PCU 197-34A - Topo "B" Section 34, T1S, R97W, 6th P.M. Piceance Development Project

ExxonMobil Oil Corporation

ADDENDUM TO LEGAL PLATS FOR

WELL PAD (PICEANCE CREEK UNIT 197-34A)

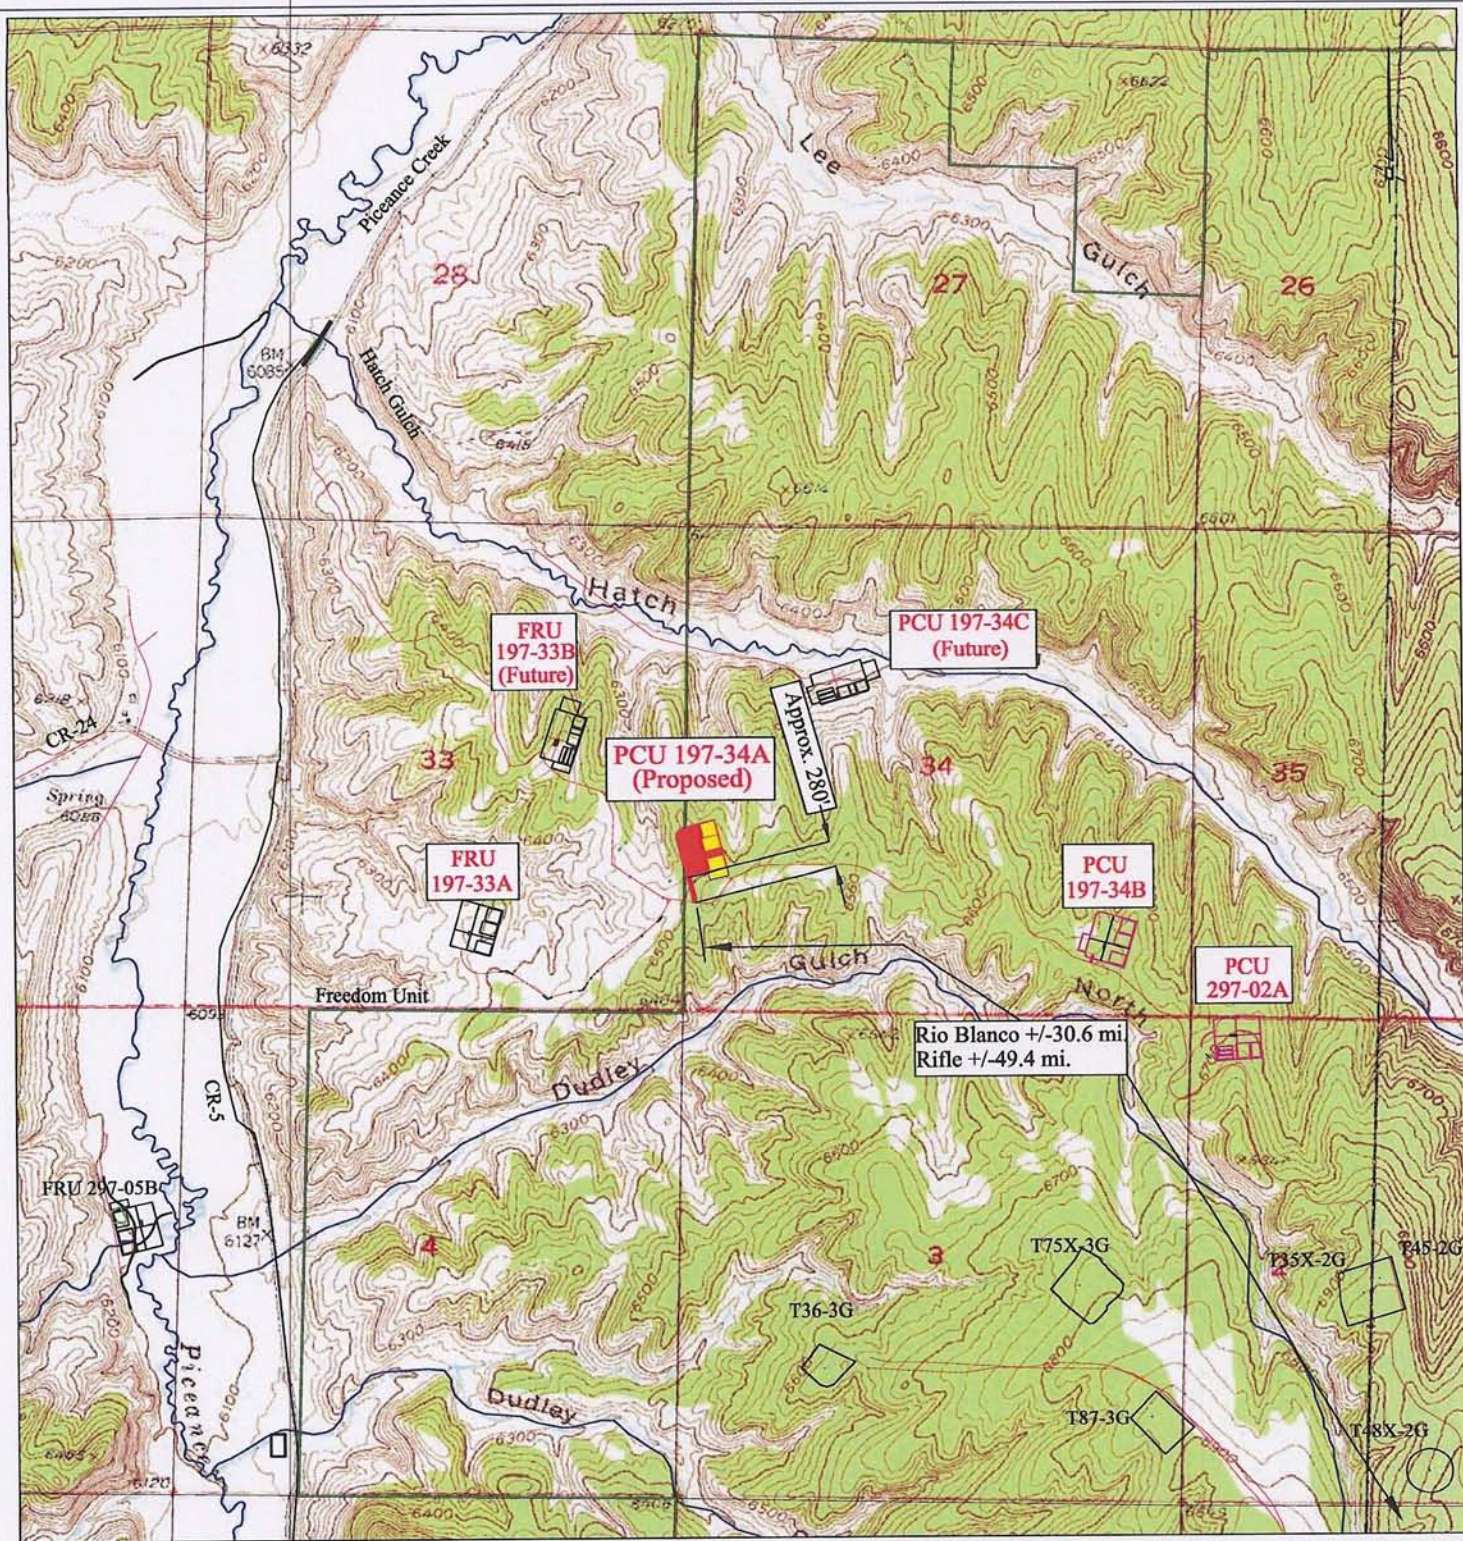
P1	9 JAN 09	Deleted Hatch Gultch Access			CEL	CEL	WFD
P	2 JULY 08	Preliminary		----	SB	SB	WFD
REV.	DATE	REVISION DESCRIPTION		ENG.	DRAWN	CHECKED	APPROVED

PCU 197-34A - Topo "D" Section 34, T1S, R97W, 6th P.M. Piceance Development Project

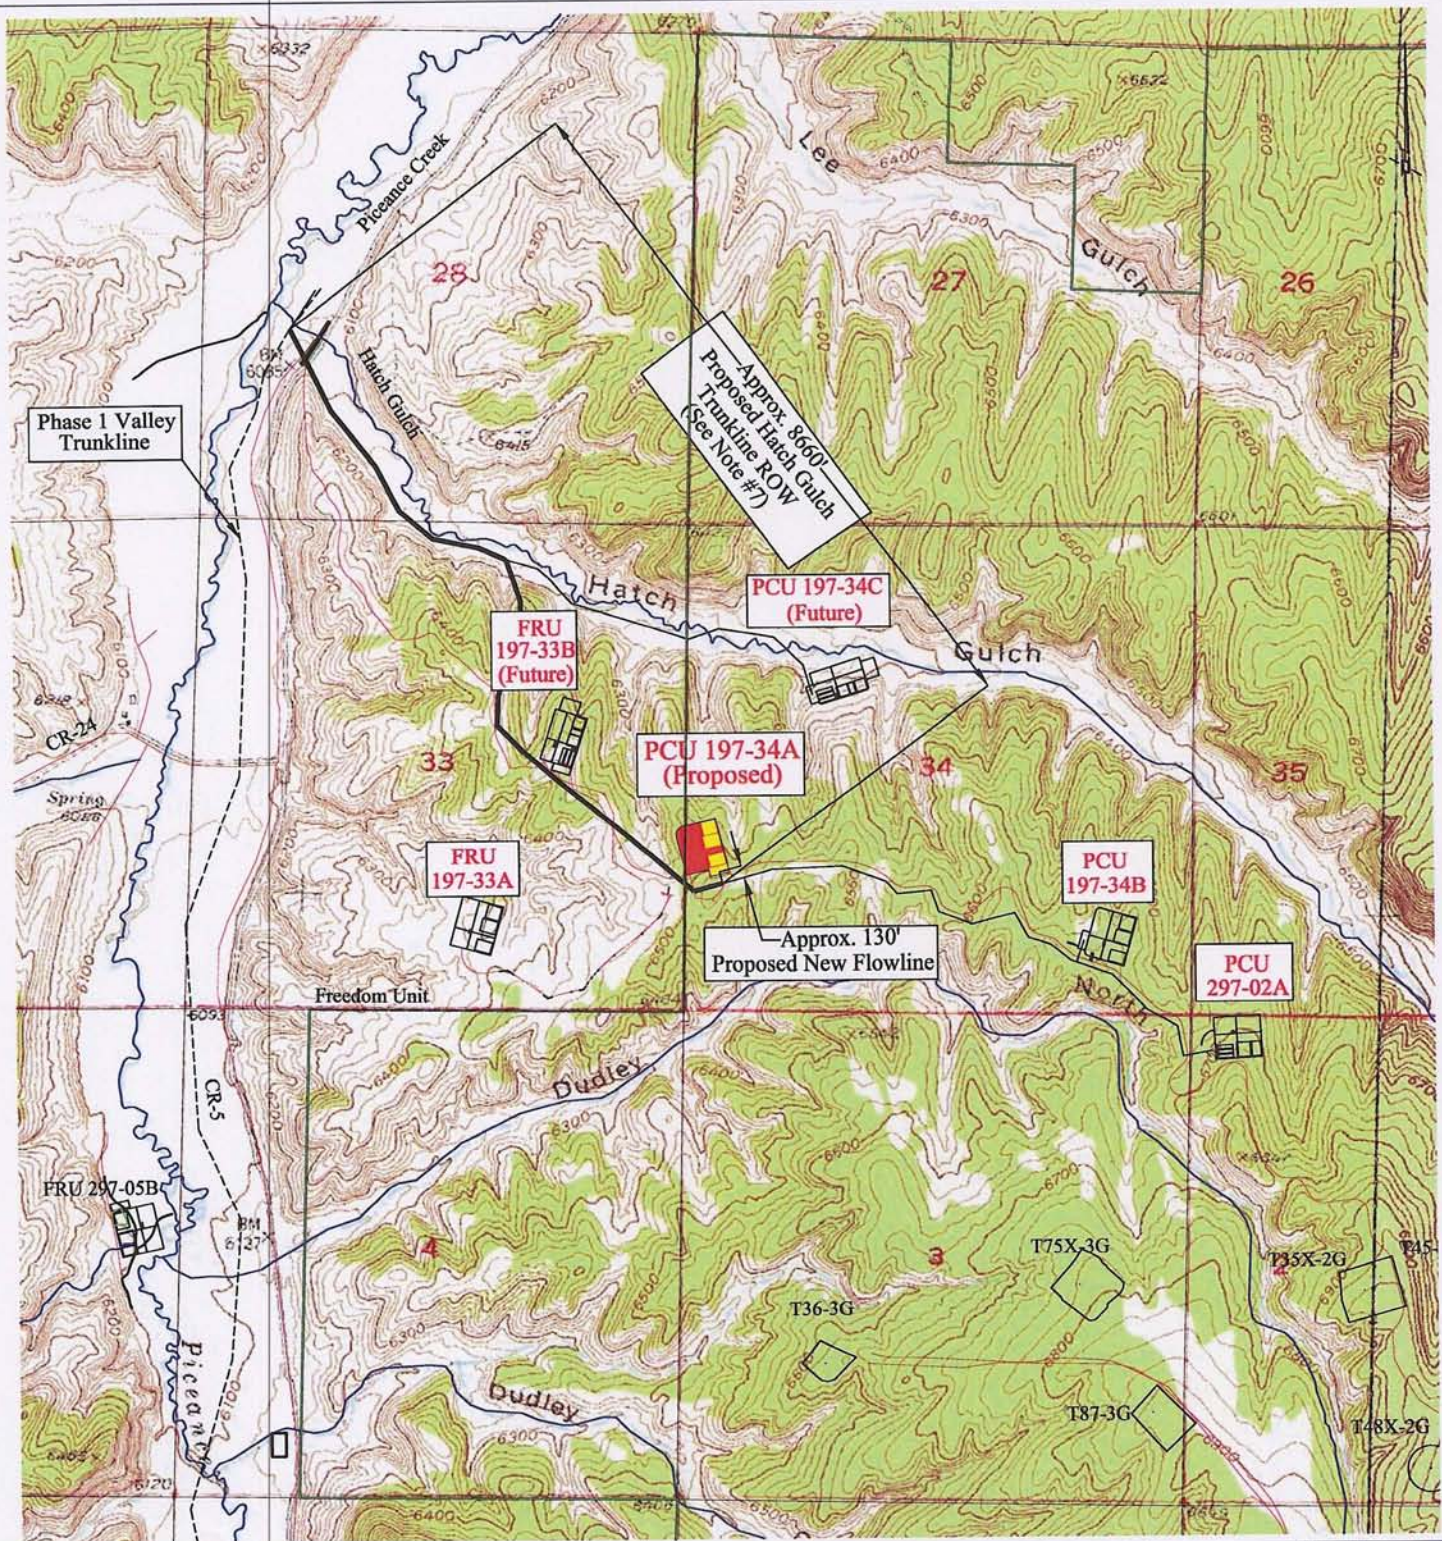
REV.	DATE	REVISION DESCRIPTION	ENG.	DRAWN	CHECKED	APPROVED
P1	13 JAN 09	Deleted Hatch Gulch Access	----	CEL	CEL	WFD
P	1 JULY 08	Preliminary	----	SB	SB	WFD

Water Haul Routes - FRU 197-34A Section 34, T1S, R97W, 6th P.M. Piceance Development Project

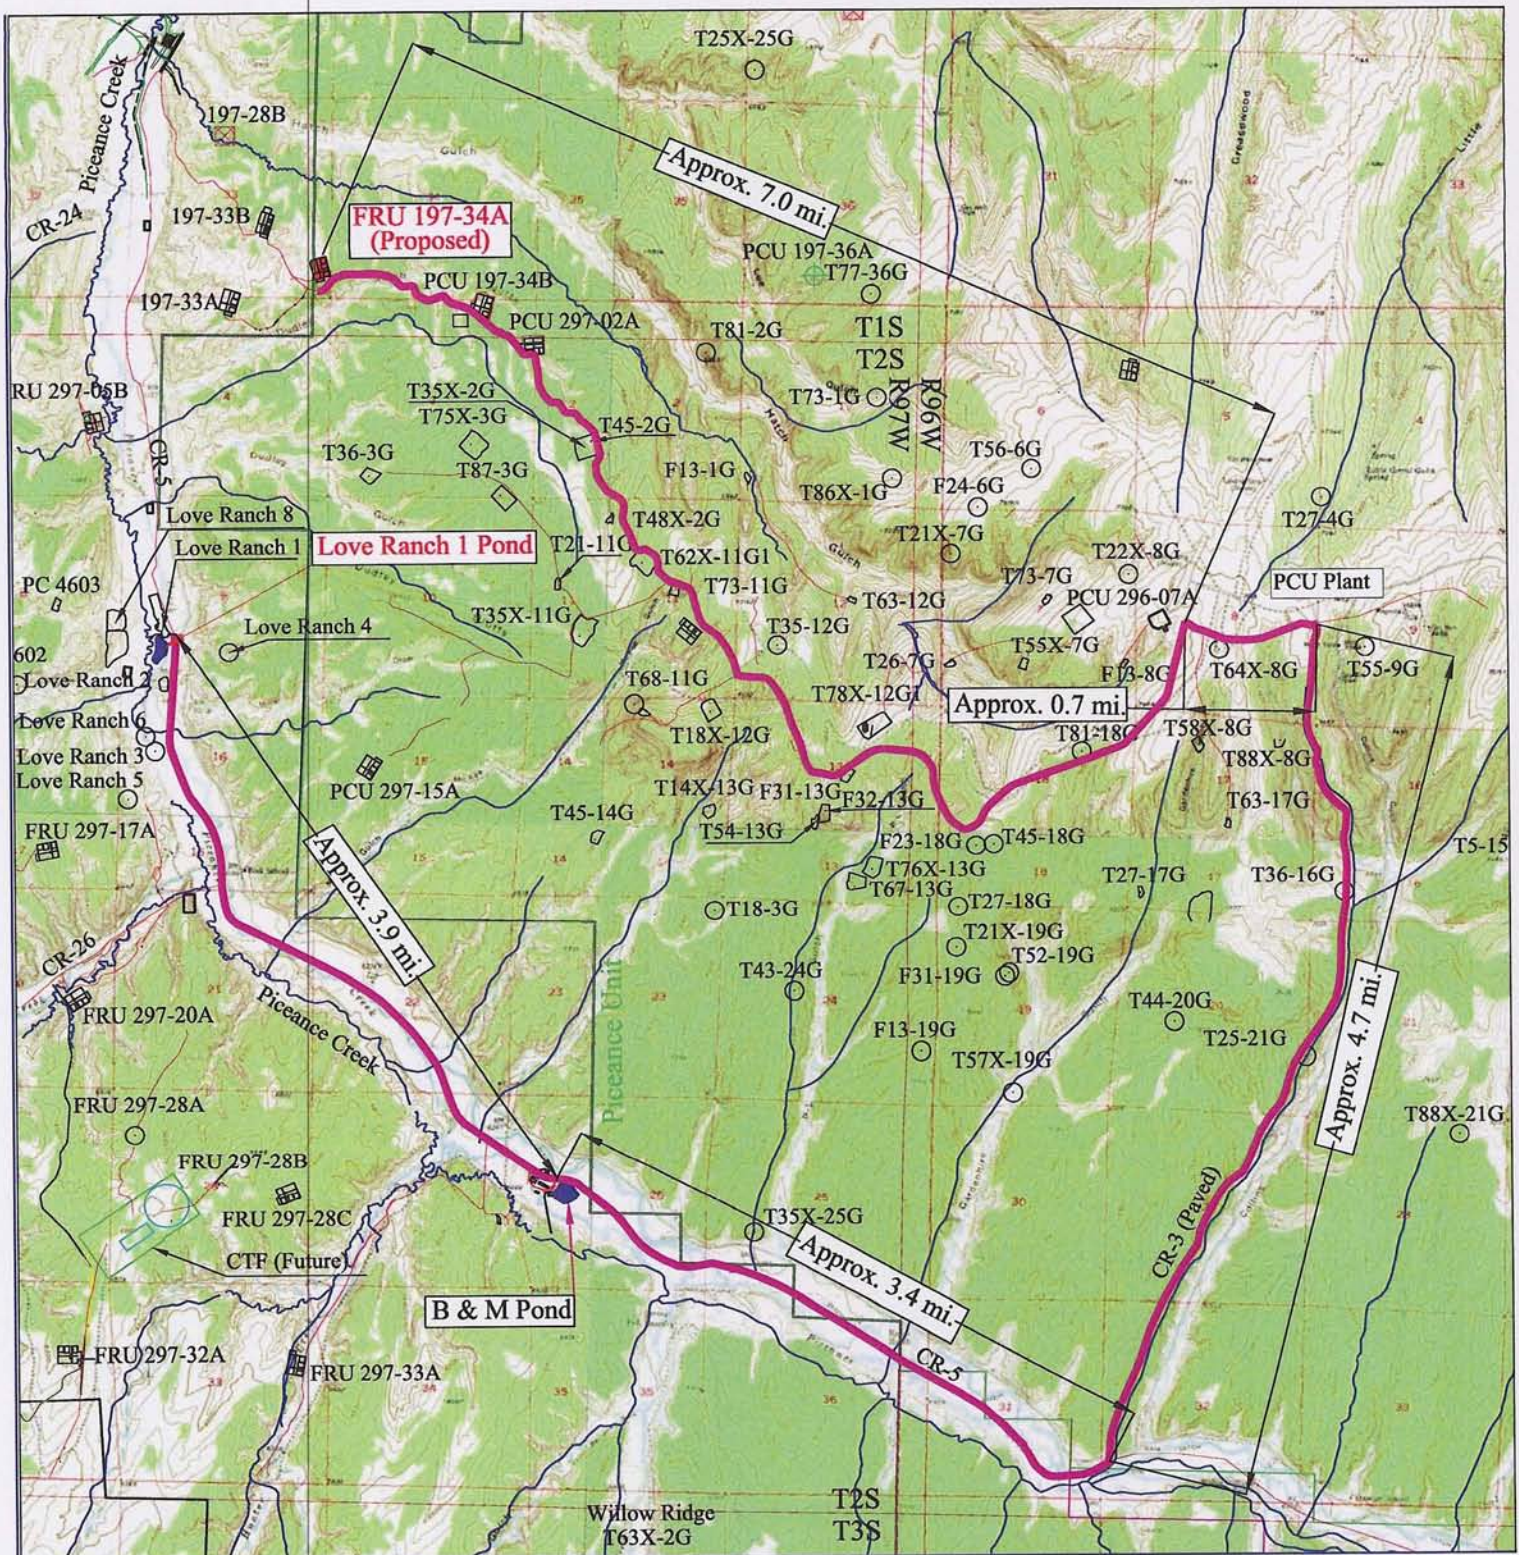
REV.	DATE	REVISION DESCRIPTION	ENG.	DRAWN	CHECKED	APPROVED
P1	9 Jan 09	Deleted Hatch Gulch Access	CEL	CEL	WFD	
P	20 JUNE 08	Preliminary	SB	SB	WFD

Production Facilities Plot Plan PCU 197-34A Piceance Development Project

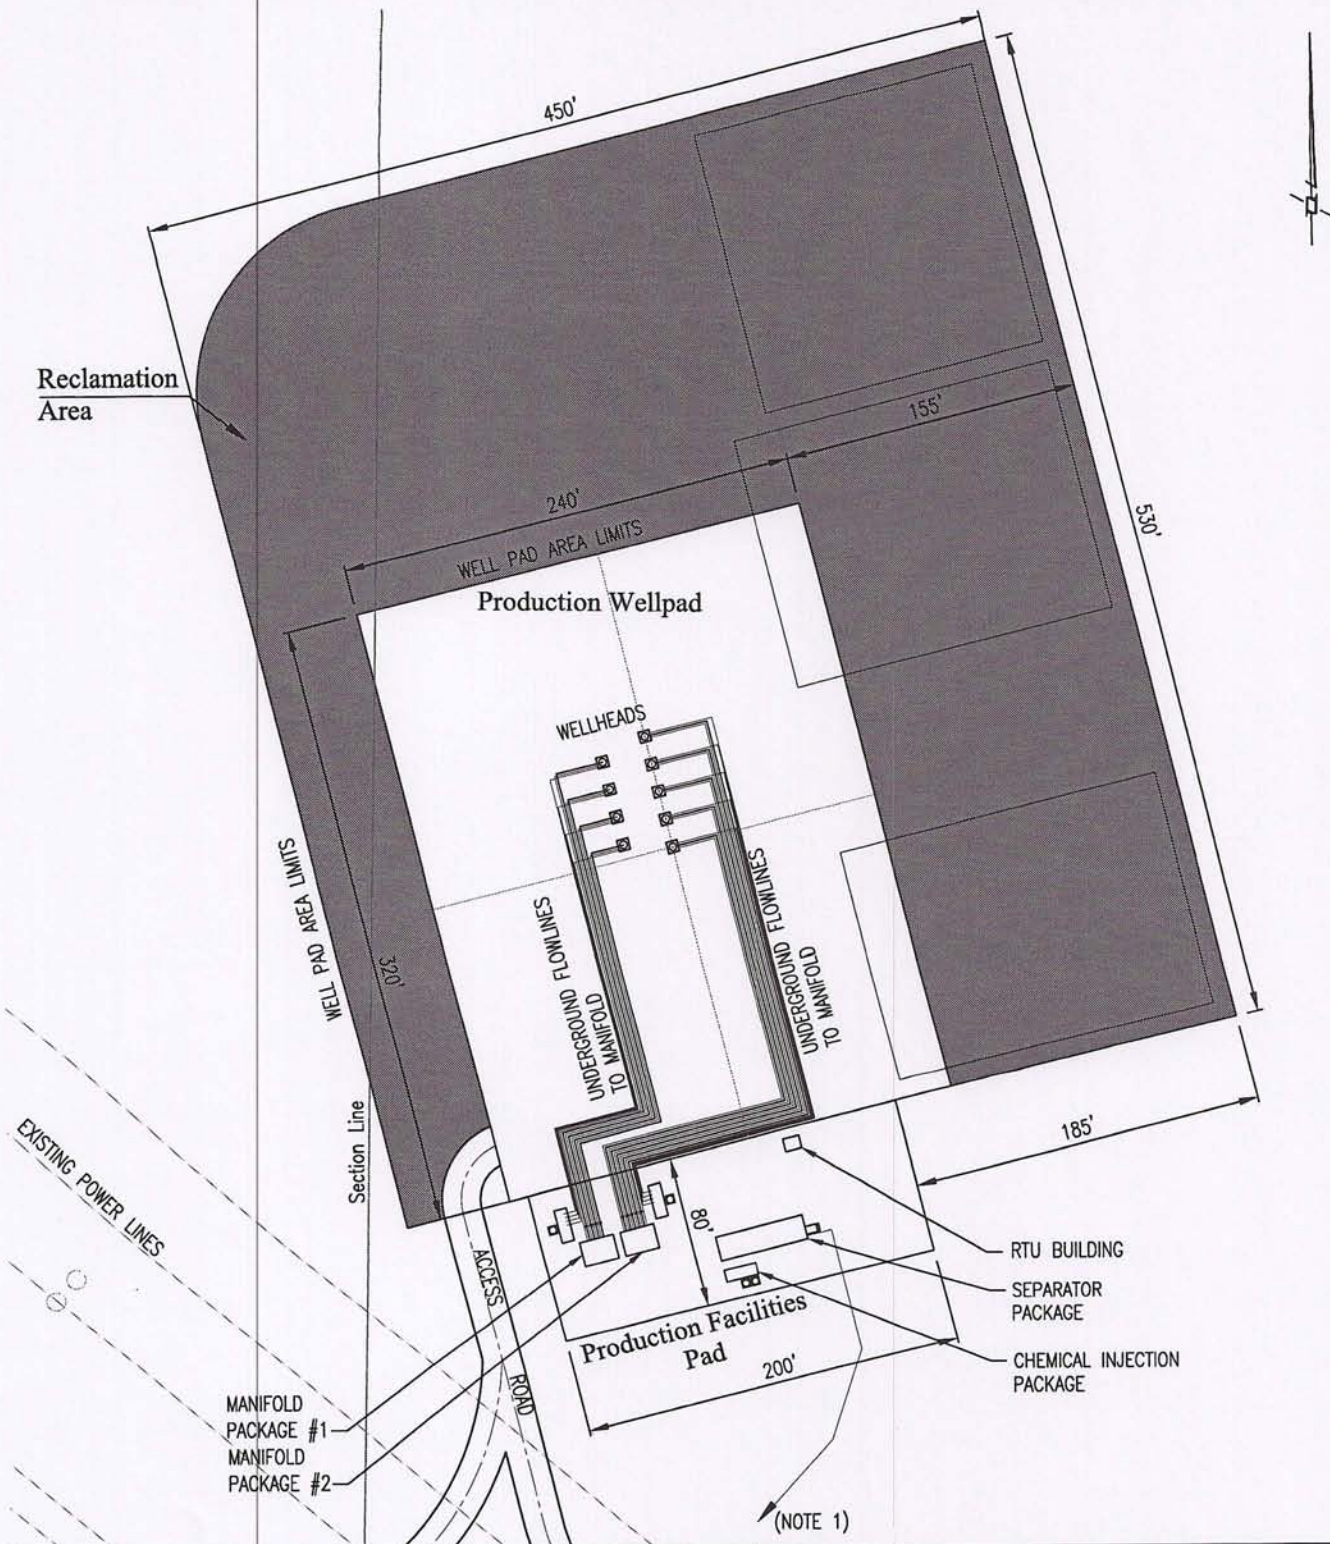
REV.	DATE	REVISION DESCRIPTION	DRAWN	CHECKED	APPROVED
B	29 Jan 09	Modify Wellpad Entry	CEL	CEL	WFD
A	17 Nov 08	Preliminary	CEL	CEL	WFD
